Executive Director's Recommendation

Commission Meeting: December 3, 2015

PROJECT Franklin Park Rehabilitation 14th and I Streets, NW Washington, DC	NCPC FILE NUMBER 7545
SUBMITTED BY National Park Service	NCPC MAP FILE NUMBER 21.00(70.00)44260
REVIEW AUTHORITY 40 U.S.C. § 8722(b)(1) and (d)	APPLICANT'S REQUEST Preliminary approval of site and building plans
	PROPOSED ACTION Approve with comments
	ACTION ITEM TYPE Staff Presentation

LIVING

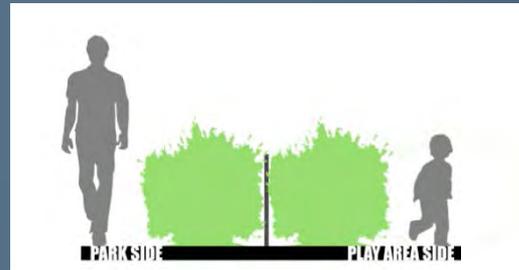
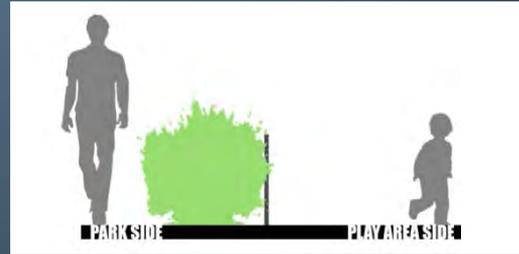
- Per the MOA signed on June 3, 2015 pursuant to Section 106 and 110 of the NHPA, incorporate the Potomac watershed theme throughout the design.
- Identify the type and location of specific play elements to be located within the Children's Garden.
- Consider use of the "living" fence as the preferred option to best integrate the protective measures necessary for a safe play space with the organic design of the park.

The new rehabilitation design proposes an approximately 12,000 sf space to serve as a children's garden and play space. Taking its cues from the park's pastoral setting and ecological context as part of the Potomac watershed, many of the proposed elements embody a more natural approach to play than typically found in Washington playgrounds. Staff is supportive of this departure from the more traditional play space as it embodies the spirit of Franklin Park, which continues to serve as a respite from the urban activity of downtown Washington. As safety is of highest importance in a children's play area, staff recommends inclusion of additional design details on the play elements in the final submission, and also recommends use of the "living" fence identified in the preliminary design's fencing options (*please see slide 22 for options*).
